ANN ARBOR HISTORIC DISTRICT COMMISSION**Staff Report****ADDRESS:** 221 Eighth Street, Application Number HDC22-1115**DISTRICT:** Old West Side Historic District**REPORT DATE:** July 14, 2022**REPORT PREPARED BY:** Jill Thacher, Historic Preservation Coordinator**REVIEW COMMITTEE DATE:** Monday, July 11, 2022

APPLICATION: The applicant seeks HDC approval to construct a bilevel rear deck 6'6" to 8'6" above grade (over a walkout basement), made of composite wood with an aluminum guardrail.

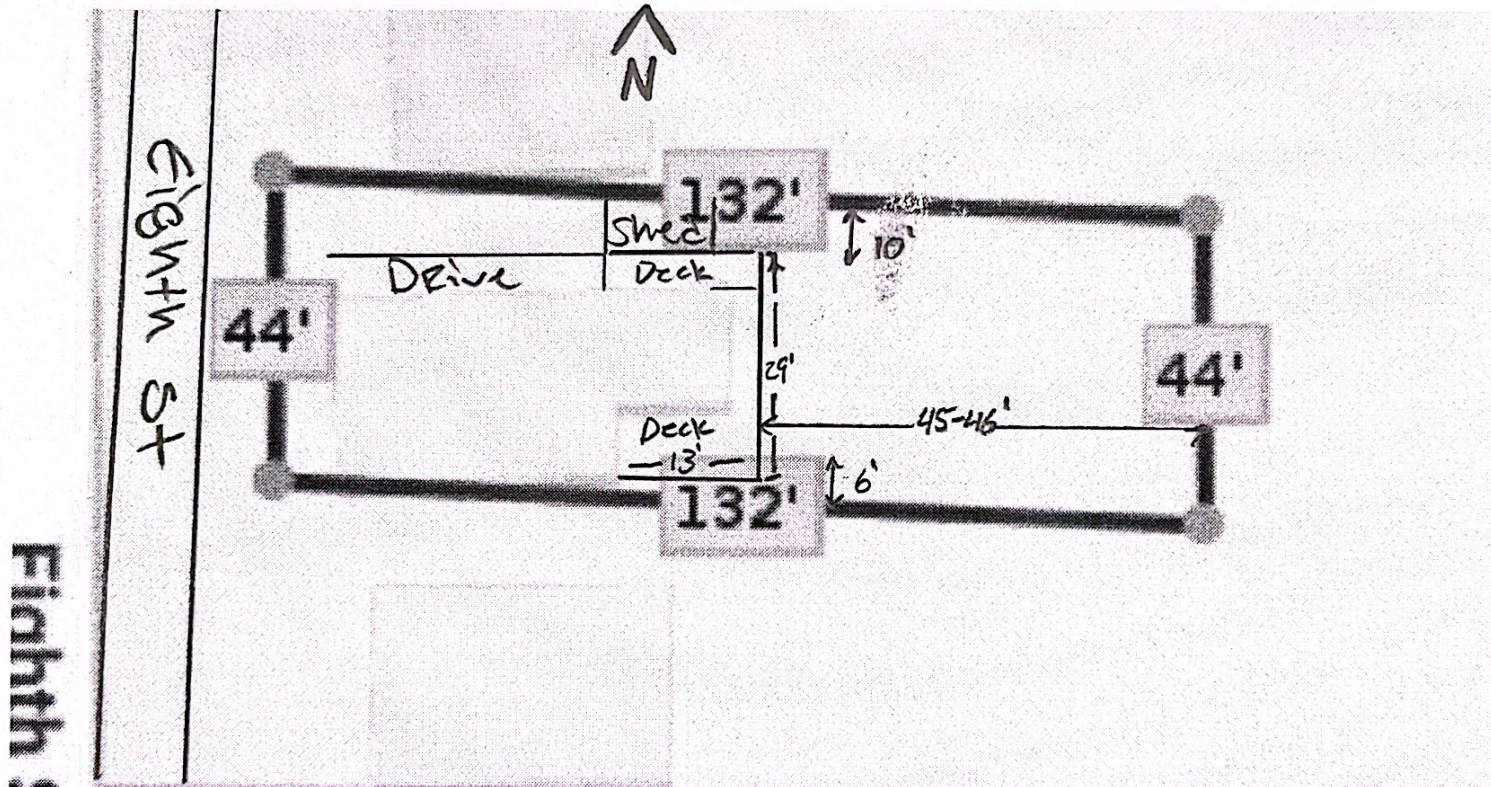
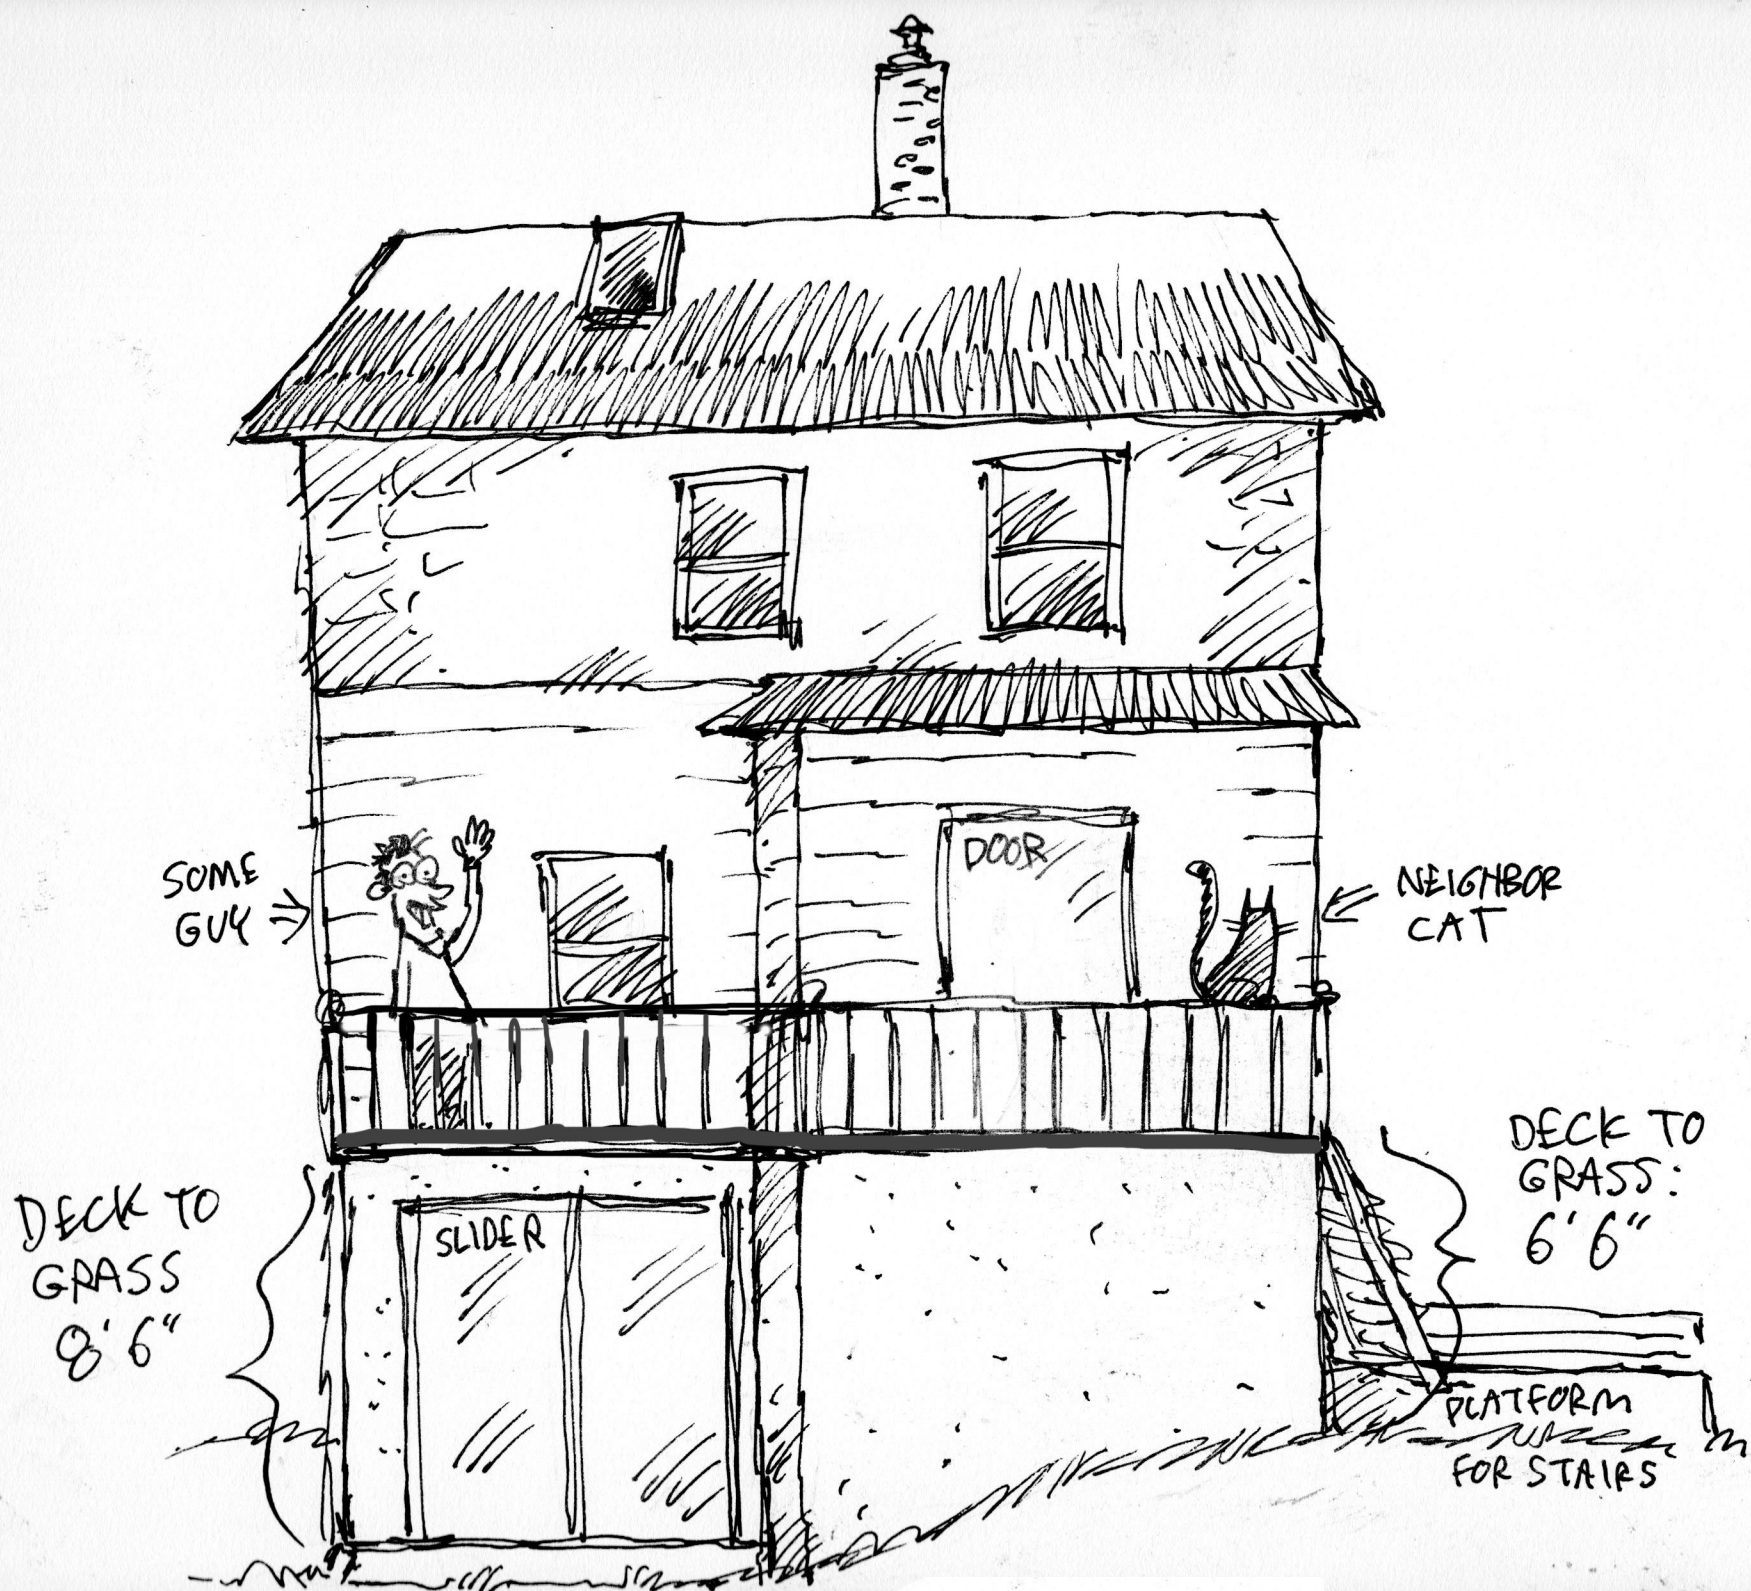
1. On the north side, will the deck be flush with the north elevation of the house? Or will it extend beyond the house wall to the north or be inset (if so, how much)?
2. I'm having trouble visualizing the stairs and lower deck. I get that the lower deck extends between the house and shed, and it looks like there is a retaining wall between the end of the driveway and the backyard. Will the lower deck be flush with the driveway, and run along the trim board on the side of the shed? What are the lower deck dimensions?
3. From the given site sketch, I can't tell where the stairs start and end. Do they get from the upper to the lower deck. Will those end at the northeast corner of the house? I have for and do they extend before hitting the lower deck?

Is it possible to have a side drawing that shows a view down the driveway and the stairs coming off the house and where they'll land, and another of the north elevation at the back corner? Sketches don't need to be fancy, but it's important to make clear how visible the stairs will be from the driveway. I can see why you don't want the stairs to go straight off the back into the backyard (that's a long way away, and on a sloped yard).

The small deck next to the driveway will have one step onto the deck. You'll be able to walk from the driveway to the steps of the deck. If we don't do that then we'll have to walk down two steps into grass and mud and then up more stairs to the deck (see the picture below). Yes, it extends beyond the house so that you can walk up the stairs. Yes, you'll be able to see the stairs, just like our old deck. The lower deck is 8' 0" x 17' in the stairs that go to the back yard (the measurement also includes the stairs that go up to the deck). You can see this on the builder's drawing, which also shows the steps to the lower deck.
